May 2, 2013

**Re: Submission of Comments on Framework Document for Commercial and Industrial Pumps; Docket EERE-2011-BT-STD-0031; RIN 1904-AC54**

**Figure 1: 3D Plot of the MEI Equation.**

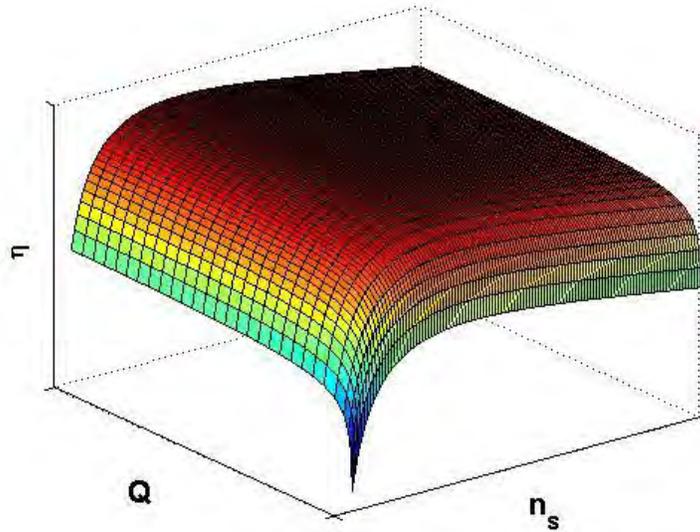
The plot can be moved up and down vertically along the efficiency ( $\eta$ ) axis by changing the constant “C” at the end of the equation. It is this “C” factor that allows the equation to be fitted to the various pump types and different operating speeds.

HI urges that the “C” coefficient alone be used to modify the efficiency cut off level (thresholds) for each MEI level, as was done in the EU. HI recognizes, based on its analysis, that better data fits could be obtained through the use of changing the “a” through “e” coefficients in the three dimensional quadratic polynomial equation or that completely different forms of equation may provide more precise data fits. HI does not, however, believe that the complexity of these options is warranted and submits that it will not yield significant improvement in the ability of the equation to represent a cut off level for pump efficiency. Further, doing so places significantly greater regulatory burdens on the U.S. pump manufacturing industry, restricts export opportunities to markets and countries that adopt the EU standard and/or regulation, and creates increased compliance issues for imported pump products that are subject to different efficiency metrics while only serving to disadvantage U.S. pump manufacturers and their competitive position globally.

**Figure 1.1.4.1 — General impeller types**

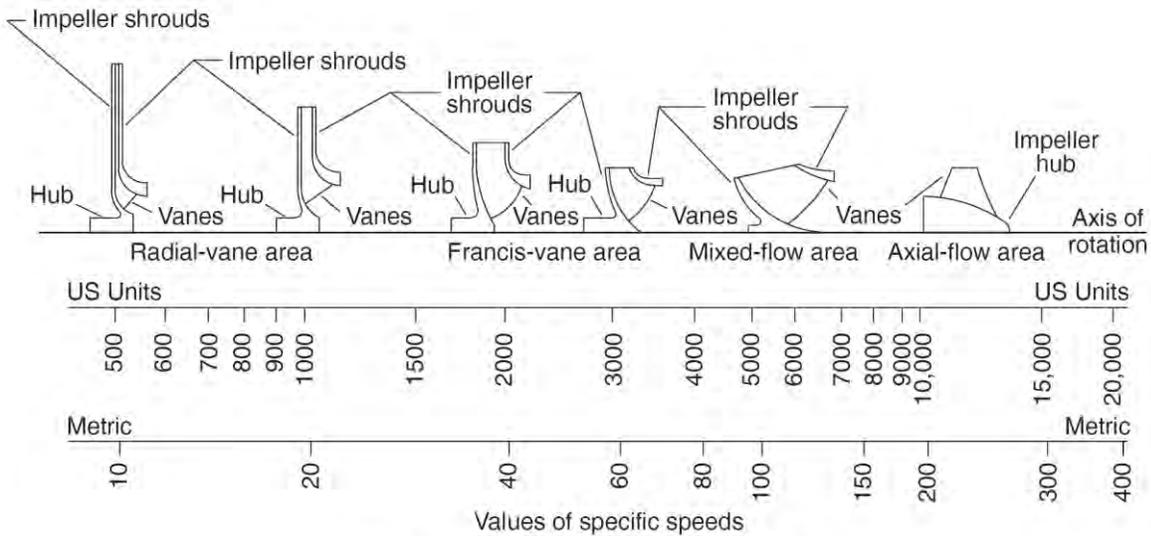
**Item 1-25:** Item 1-25 DOE requests comment on what minimum specific speed should define the axial/propeller and mixed flow water pump.

As can be seen in ANSI/HI Figure 1.1.4.1, mixed-flow pumps begin at approximately 4500 specific speed, and axial-flow propeller pumps start at approximately 8000 specific speed.
